**UNITED STATES ENVIRONMENTAL PROTECTION AGENCY  
REGION 10**

**Written Comments Received from Public Hearing on Clean Water Act Section 401(a)(2)  
Objection to EPA's Draft National Pollutant Discharge Elimination System (NPDES) Permits for  
Lower Columbia River Federal Hydroelectric Projects**

**June 7 - 21, 2022**

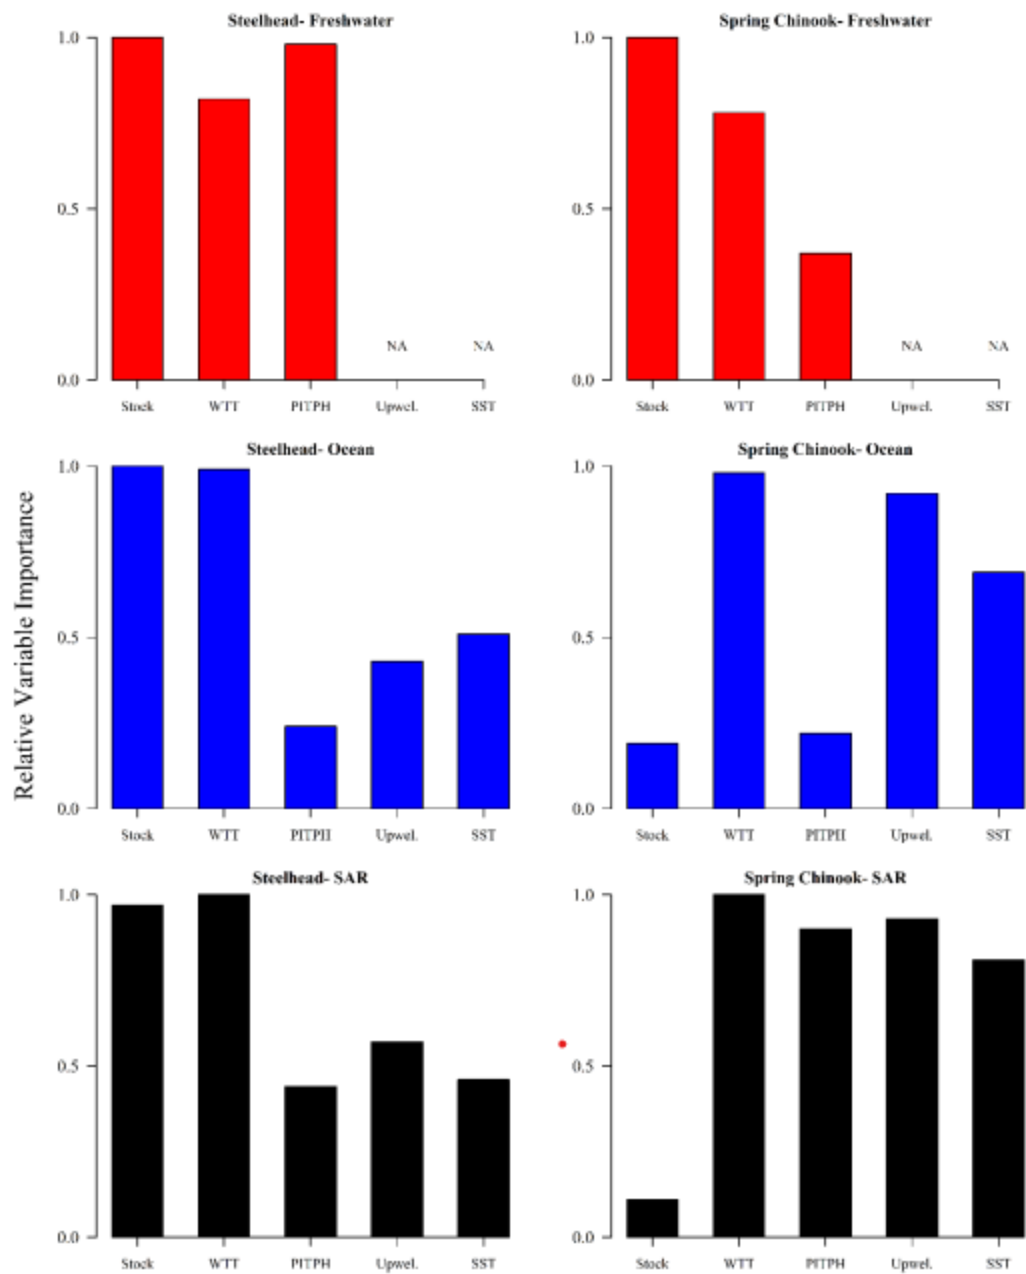
Lowering the reservoir profile not only helps lower temperatures, but it also improves water transit time (WTT). According to the Comparative Survival Study (CSS), WTT is one of the main drivers of wild steelhead and wild spring Chinook survival at multiple life stages. (see Figure 2.9, below from the CSS)
